**Notice of Allowability**

10/756,929

MEYER, DONALD W.

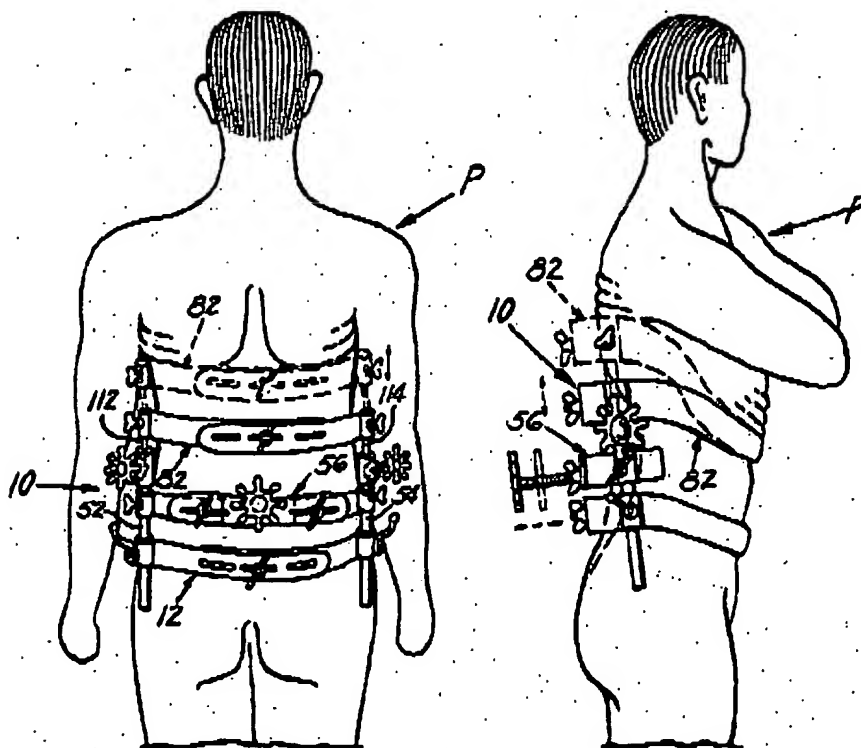
Stabholz (US Pat. No. 2,835,247), shown in the figures below, discloses a lumbar traction apparatus comprising first and second elongate bracing rods (52, 54) that are disposed generally parallel to one another and positioned on opposite sides of an individual; a posterior traction belt (82) that extends across the uppermost ends of the bracing rods, and that can be positioned across the individual's chest (note Figure 2); and a belt assembly (12) and a pad assembly, which comprehend Applicant's 'at least two anterior traction slings', that can be positioned against an individual's thoracic vertebrae or lumbar vertebrae.

Stabholz fails to disclose or make obvious a pelvic arch affixed to and extending from the lowermost ends of the bracing rods, or a support bar that extends from the top most ends of the first and second bracing members and that extends behind the user's neck and shoulders.

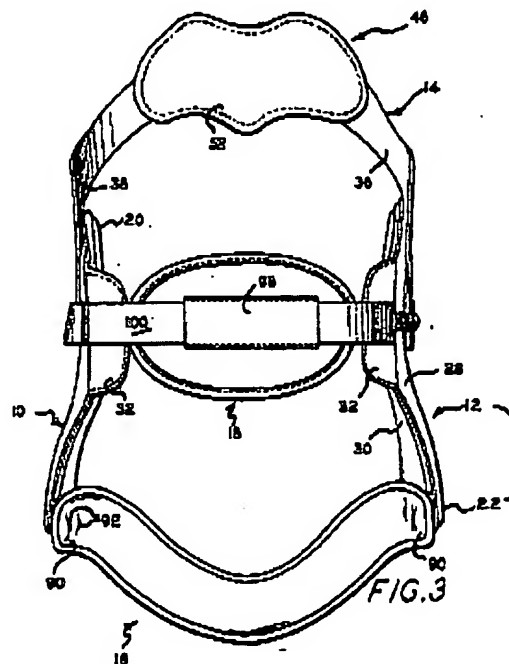
Connelly (US Pat. No. 3,220,407), shown in the figure below, discloses a back brace comprising first and second rigid, parallel bracing members (10, 12) positioned on opposed sides of an individual; a sternal pad support bar (14), or 'posterior traction belt', that is positionable across an individual's chest; a lumbar engaging portion (18) comprising a belt (100), or an 'anterior traction sling', extending across an intermediate portion of the first and second bracing members and that is positionable against an individual's lumbar vertebrae as it is part of the lumbar engaging portion; and a pelvic arch (16) affixed to and extending from the lower most ends of the first and second bracing members and is operative to be positioned against a portion of the user's pelvic region (column 3, lines 68-75).

Connelly fails to disclose or make obvious at least two anterior traction slings or a support bar that extends from the top most ends of the first and second bracing members and that extends behind the user's neck and shoulders.

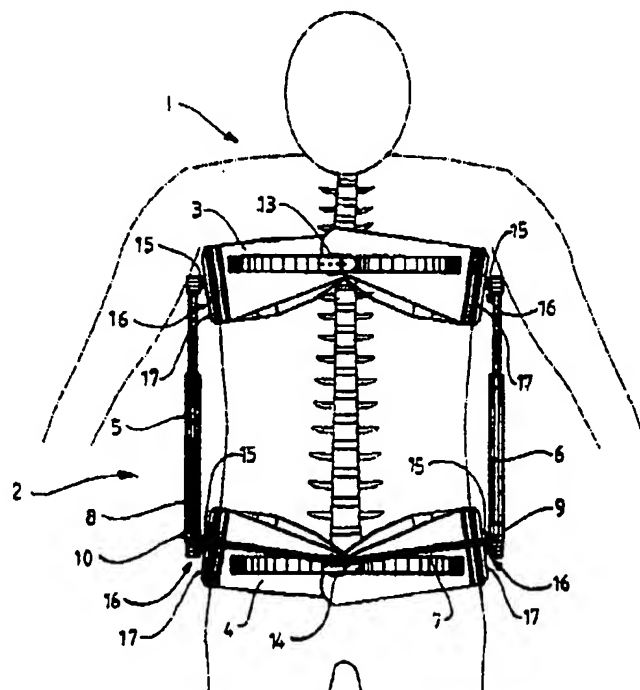
Ousdal (US Pat. No. 6,210,354), shown in the figure below, discloses a device comprising pneumatic cylinders (5, 6) that are parallel to one another and positioned on opposite sides of an individual, which, absent further limitation, comprehend Applicant's first and second bracing rods; a breast belt (3), or posterior traction belt, that extends across the uppermost ends of the cylinders and positionable across an individual's chest; a hip belt (4) that is affixed to and extends from the lowermost ends of the cylinders and is positioned against the anterior section of an individual's hip joints; and a neck stretcher (19) that comprises a neck support that extends behind the user's neck and a yoke shoulder supports (24, 25) and a back piece (27) all of which extend behind the user's shoulders.

Ousdal fails to disclose at least two anterior traction slings that are positionable against a region of the user's spine, and fails to specifically disclose a pelvic arch as well as a support bar that extends from the top most ends of the first and second bracing members and behind the user's neck and shoulders.

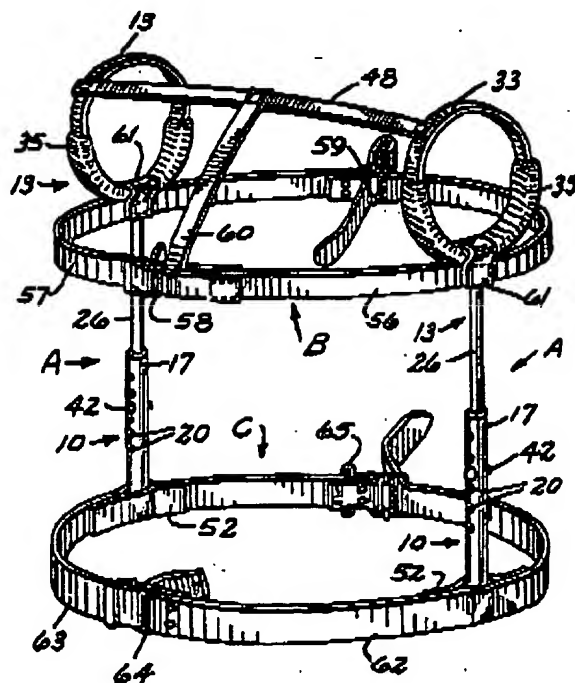
Martin (US Pat. No. 3,029,810), shown in the figure below, discloses a back brace comprising first and second elongate bracing rods (17, 26 and note Figure 5), a breast strap (44), or posterior traction belt, extending across the uppermost ends of the bracing rods and positionable across an individual's chest; a waist encircling strap (50) having hip contacting segments (12) and, due to the telescoping tubular bracing rods, can be positioned at various locations along the user's midsection including the individual's pelvic region; and straps (48, 60) that extend behind the user's neck and shoulders.

Martin fails to disclose at least two traction slings that are positionable against a region of the user's spine, and fails to specifically disclose a pelvic arch and a support bar that extends behind an individual's neck and shoulders.

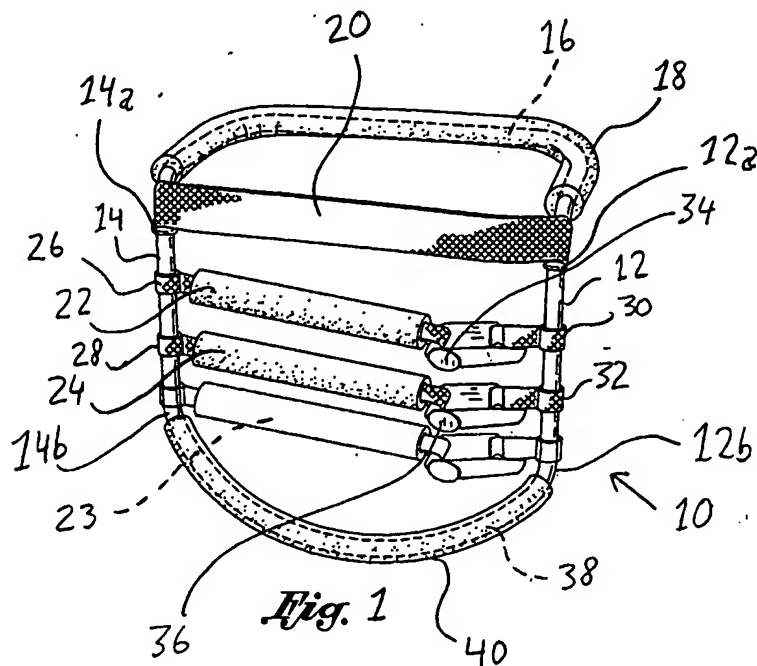
The prior art of record fails to disclose a device for supporting and bracing the thoraco-lumbar region of an individual's spine, shown in the figure below, comprising first and second elongate, parallel bracing rods positioned on opposed sides of the individual; a posterior traction belt positionable across a region of the individual's body; at least two anterior traction slings that are positionable against a region of the spine; a pelvic arch; and a support bar that is generally arcuate and extends behind the individual's neck and shoulders.
